U S NAVY RESPONSE TO SOUTH CAROLINA DEPARTMENT OF HEALTH AND
ENVIRONMENTAL CONTROL COMMENTS TO RCRA FACILITY INVESTIGATION REPORT
ADDENDUM SOLID WASTE MANAGEMENT UNIT 163 (SWMU 163) RCRA FACILITY
INVESTIGATION REMEDIAL ACTION AND SOLID WASTE MANAGEMENT UN
11/11/2003
CH2M HILL

SWMU 163/166 Zone K
R-LC on SWMU 163 RFIRA + SWMU 166 RFIRA

Re: CH2M-Jones' Responses to Comments by SCDHEC regarding the *RFI Report Addendum, SWMU 166, Zone K, Revision 0*, originally submitted on January 11, 2002, and *RFI Report Addendum, SWMU 163, Zone K, Revision 0*, originally submitted on March 22, 2002

WELL NUMBER
166GW042D

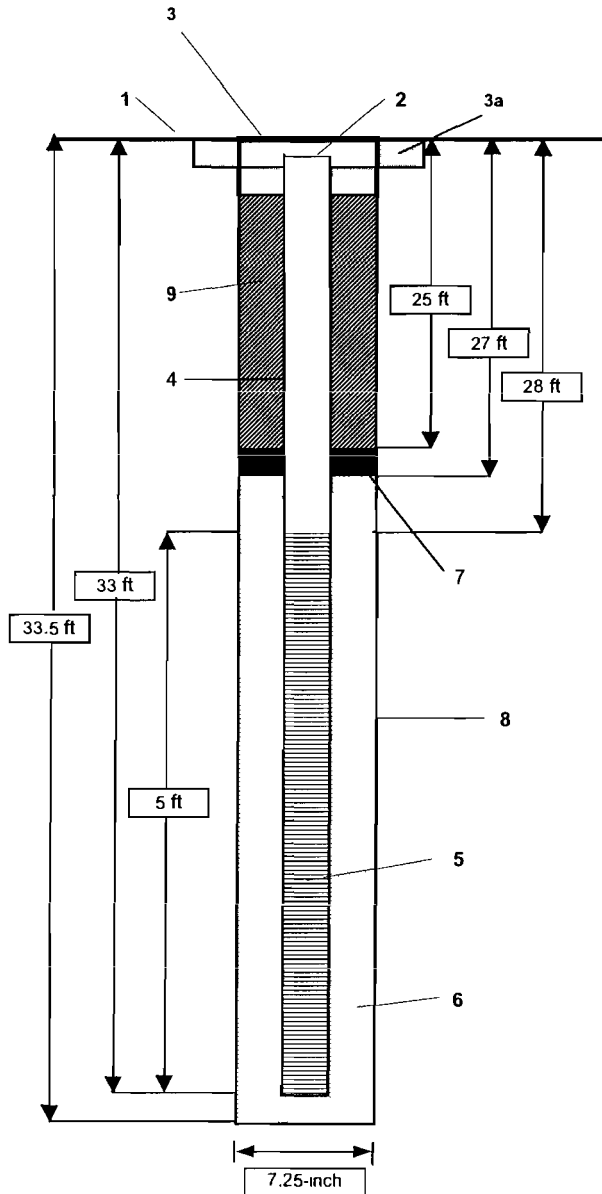
This reviewer was unable to locate copies of monitoring well logs for K166GW42D and K166GW43D. These logs would aid in determining the relationship of the wells to the top of the Ashley Formation. Please provide.

8. Provide the installation logs for K166GW42D and K166GW43D.

Monitoring well logs for K166GW42D and K166GW43D are included with this responses to comments document.

Monitoring well logs for K166GW42D and K166GW43D are enclosed with this response to comment document.
